Accessibility Survey

City of Downey Birchbark Avenue - Birchcrest Road to Vista Del Rosa Street

City of Downey Birchbark Avenue - Telegraph Road to Birchcrest Road

Date of Inspection
6/19/2017

Change in Level North of Birchcrest Road @ 33.964338146162, -118.114544749260

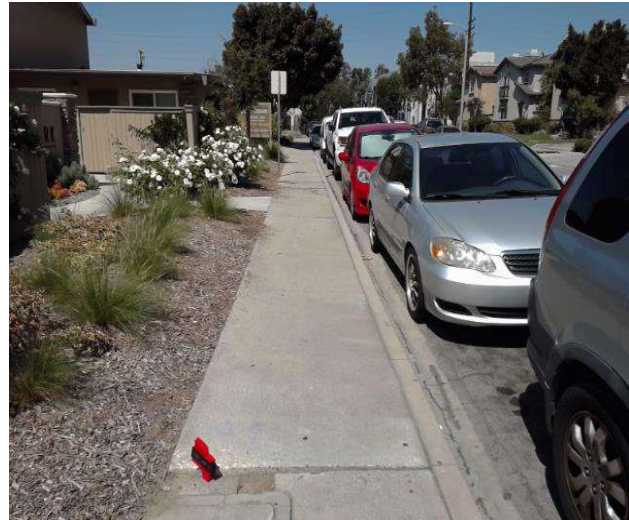
There is a change in elevation greater than recommended value.

On-Site Finding 1.50 inches

Ensure that the change in elevation is within the recommended value.

Recommendation Up to 0.25 inches
